**AMENDMENT UNDER 37 C.F.R. § 1.116**  
**U.S. Application No. 08/898,853**

This Amendment is submitted in response to the Office Action of February 23, 1999, in the above-referenced application.

FIG.2

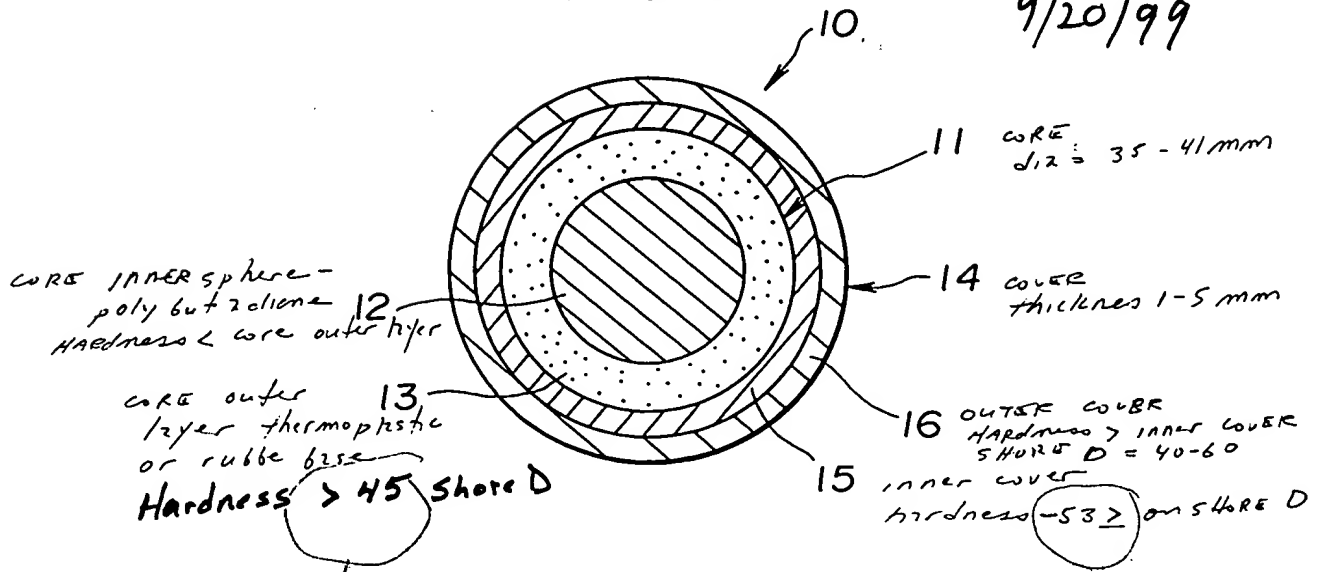
Examiner makes specific reference to claim 5 and the surrounding layer hardness of D 45 as not being indicated in the proposed drawing amendments. In response, Applicant submits herewith a further revision to Figure 2 for the Examiner's consideration. The proposed changes are shown in red ink. As can be seen, the surrounding layer 13 has been indicated as having a Shore D hardness of at least 45 degrees. Applicant respectfully submits that this should obviate the proposed drawing objections and withdrawal of the objection is respectfully requested.

Not 50  
7 45  
excludes  
45

Not  
Approved  
*SDM*  
9/20/99

claim says  
of least 45  
Not greater than 45
